Subject: Geologic Hazards Evaluation and
Preliminary Geotechnical Investigation
Response to El Paso County Review Comments
Grandview Reserve, Phase 1, Filing 1
Eastonville Road and U.S. Highway 24
Falcon, Colorado
CTL|T Project No. CS19345-115

This letter presents our response to the El Paso County review comments dated May 9, 2023. CTL|Thompson, Inc. (CTL|T) prepared a Geologic Hazard Evaluation and Preliminary Geotechnical Investigation (CTL|T Project No. CS19345-115, dated May 9, 2022) for the proposed Grandview Reserve development located east of Eastonville Road and north of U.S. Highway 24 in El Paso County, Colorado.

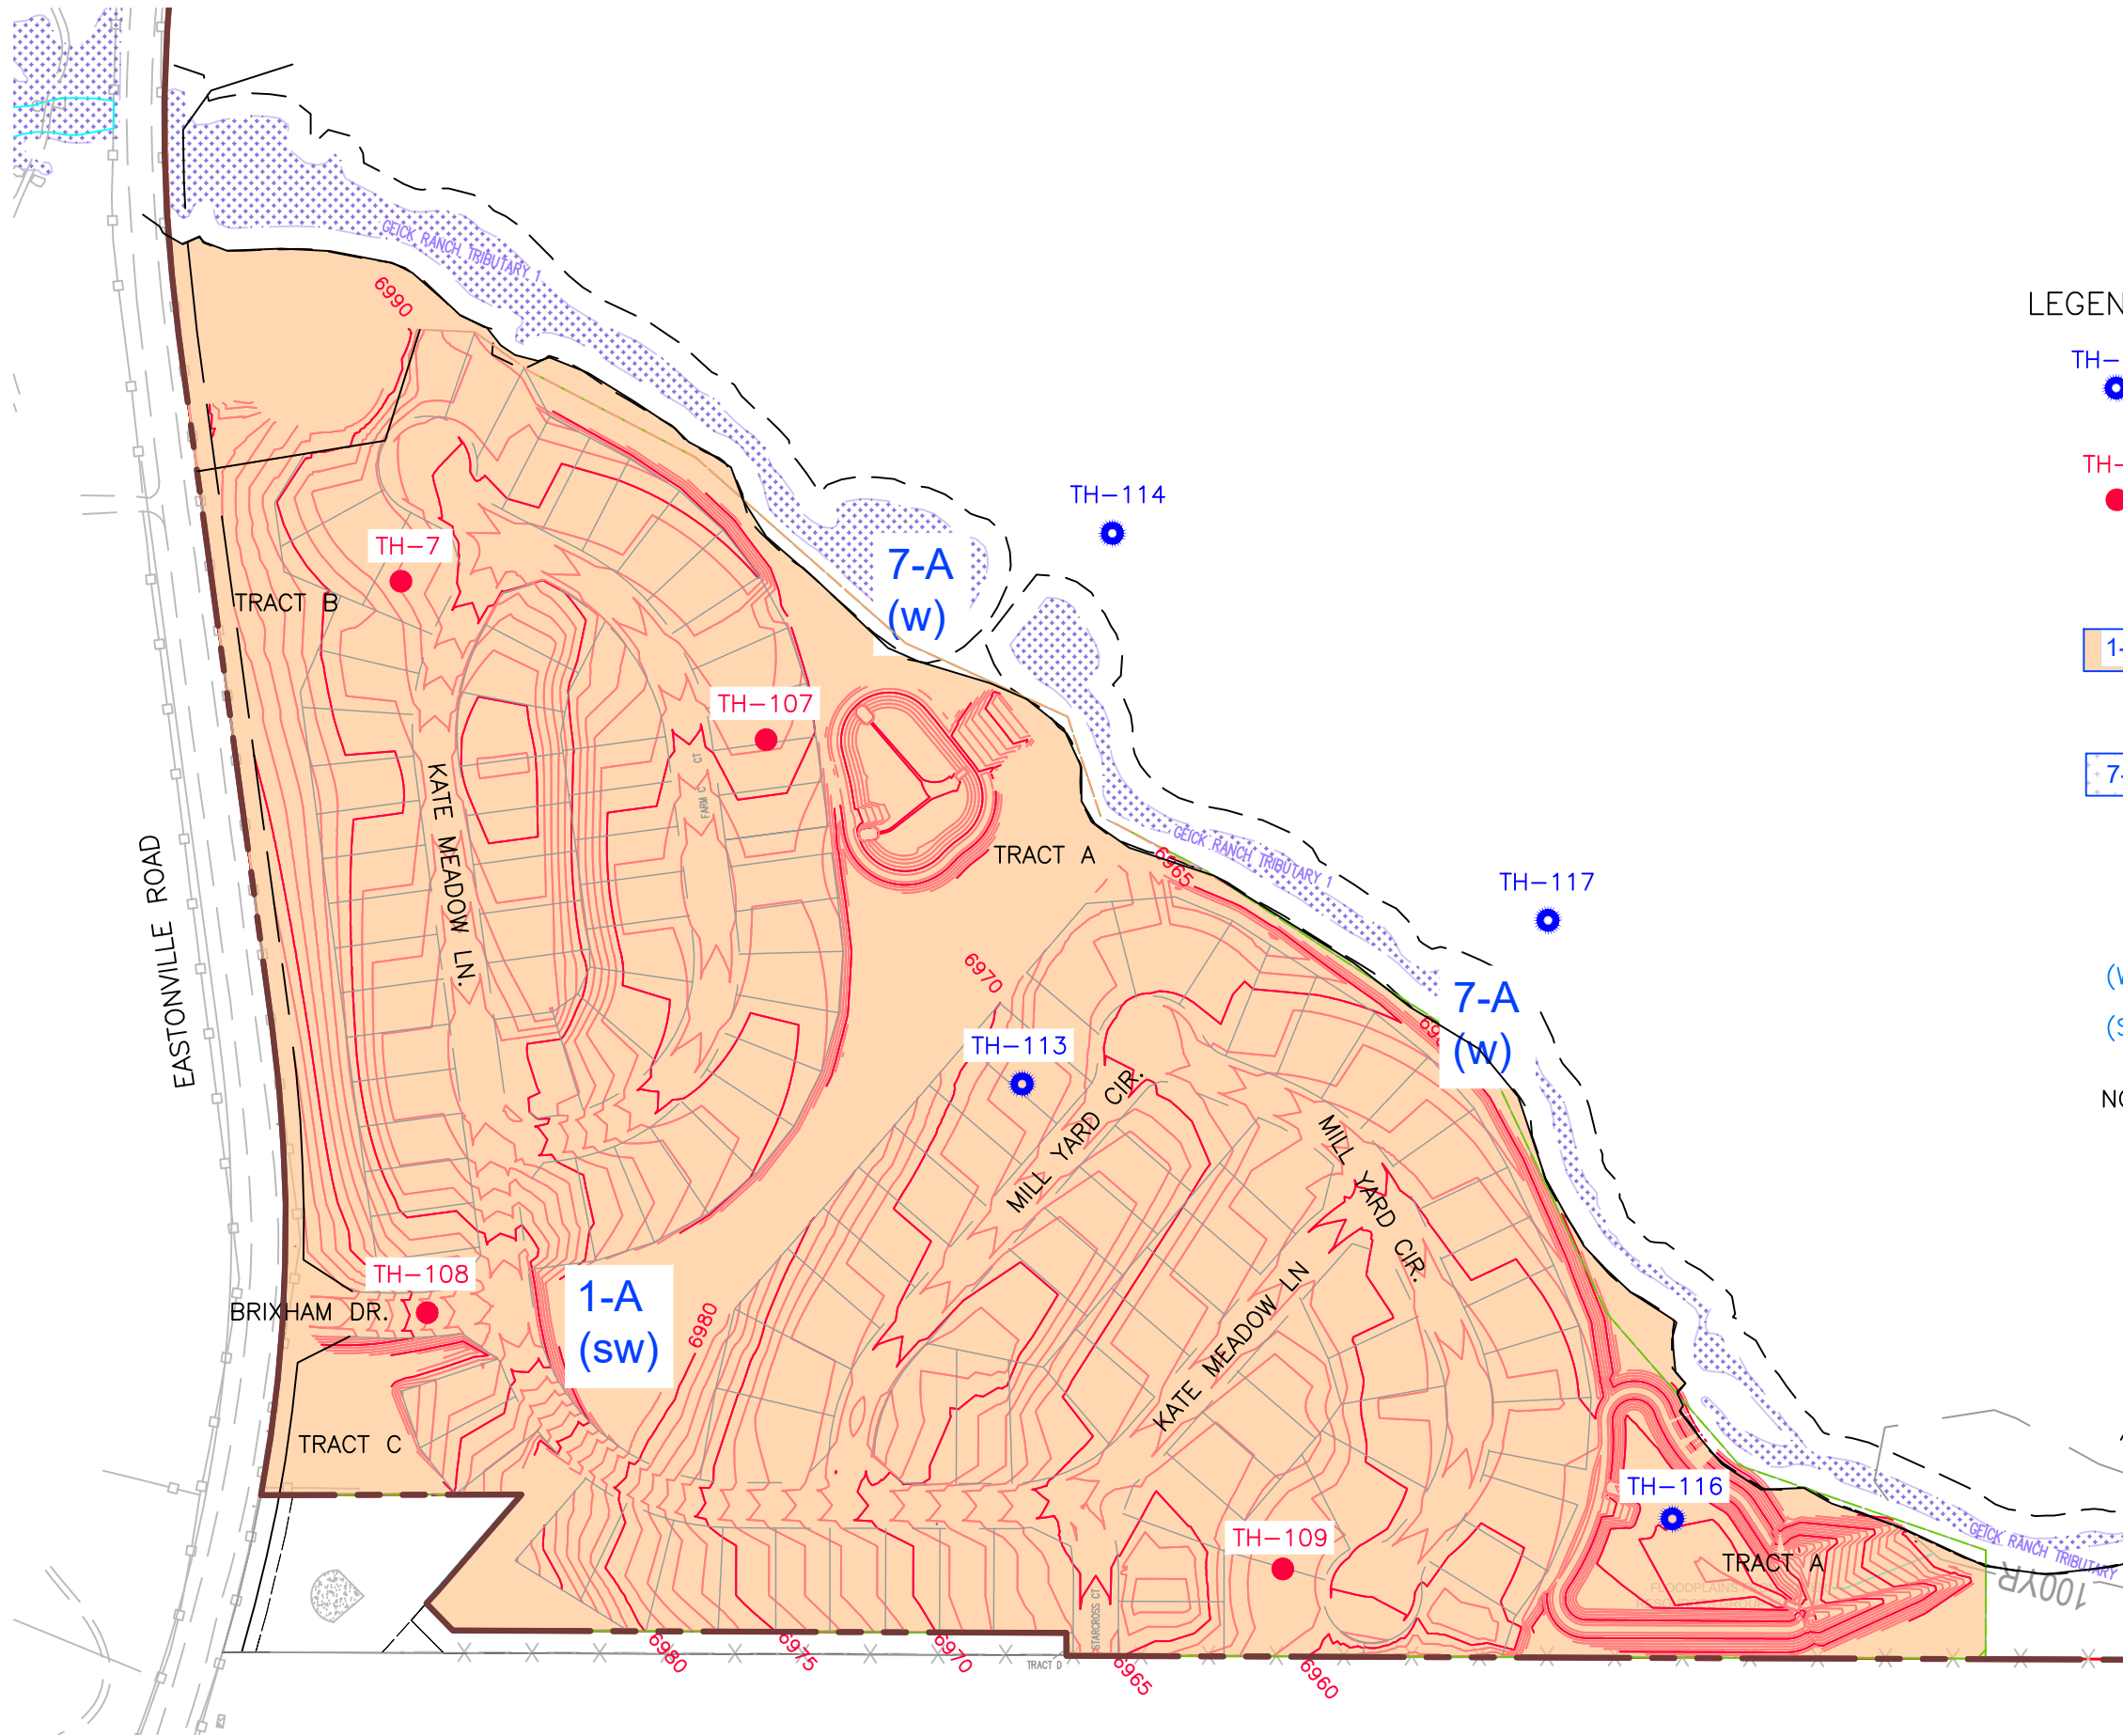
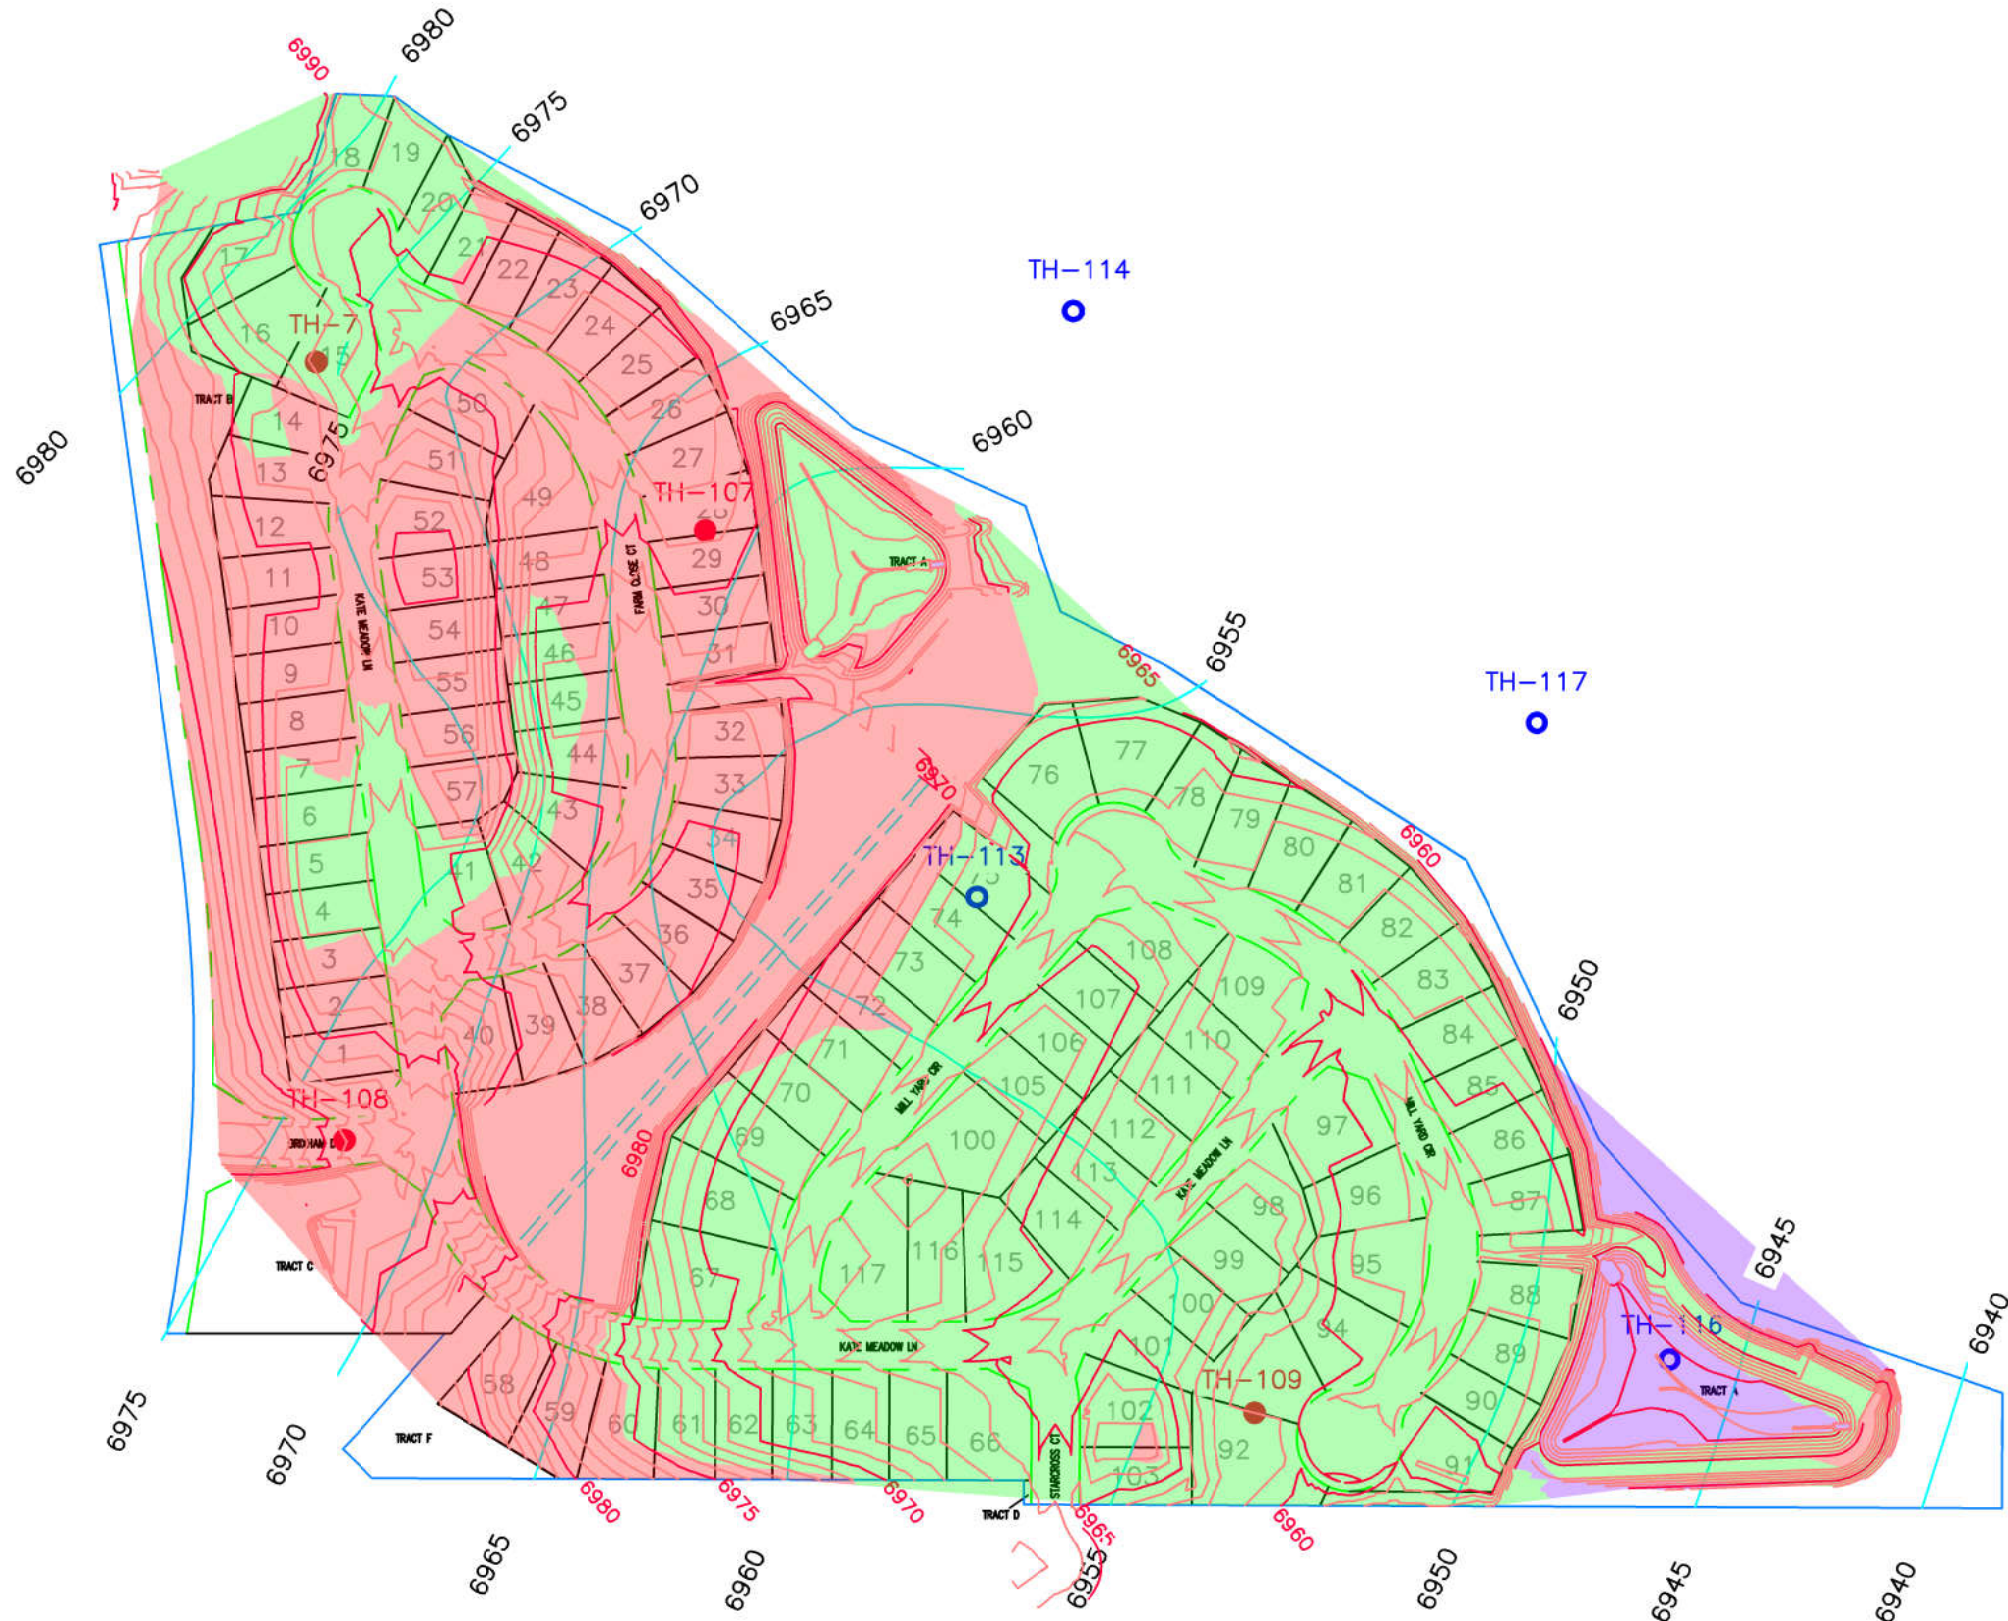
“A figure is missing depicting the various constraint and hazard mapping over the lot layout which was deferred from the prelimplan – see sample.” El Paso County requests that the subsurface conditions, site geology, and each of the geologic hazards including shallow groundwater, unusually hard rock which may cause problems with excavation, expansive soils, flooding, seismicity, erosion, radon/radioactivity, and recoverable minerals be mapped, along with estimated heave potential.

The referenced report contains a figure titled Engineering Geologic Conditions (Fig. 2). The figure indicates areas of the mapped physiographic floodplain and areas of stable alluvium. We also revised Figure 2 (attached) to clarify our interpretation of the engineering geology and to depict where flowing water may be present (in the channel) and where seasonally shallow groundwater is likely (remainder of site). A note is indicated on Figure 2 that states “Expansive soils/bedrock were found sporadically across the site. All lots may be impacted by ground heave. Total calculated ground heave ranged from less than 0.5 inches to 1 inch.” This note was included because the Dawson Formation, which underlies the site at relatively shallow depths, contains interbed-

ded and discontinuous layers of expansive claystone bedrock. This material cannot be mapped with any reasonable degree of accuracy, and it should be expected that expansive claystone may be encountered anywhere on the site. As stated in our report, lot specific soils and foundation investigations should be performed, following completion of overlot grading, to determine where expansive claystone is present and provide recommendations for mitigation.
